Access Compliance Report Public Rights-of-Way (Curb Ramps)

Main Street: BRADBURY_RD Cross Street: MONTECITO_RD Location: NW

ADA ID: RPRK211209131709 Ramp Type: Type 1 - Perpendicular Diagonal Initial Pass/Fail: Fail Overall Compliance: No Severity Score: 2

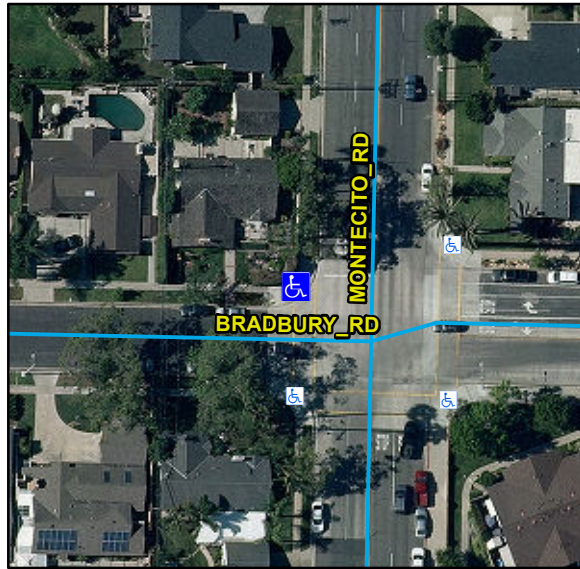
R304.2.2, R304.5.3, STD 1115

Remove & Replace Curb Ramp With Two New Directional Ramps or Equivalent.
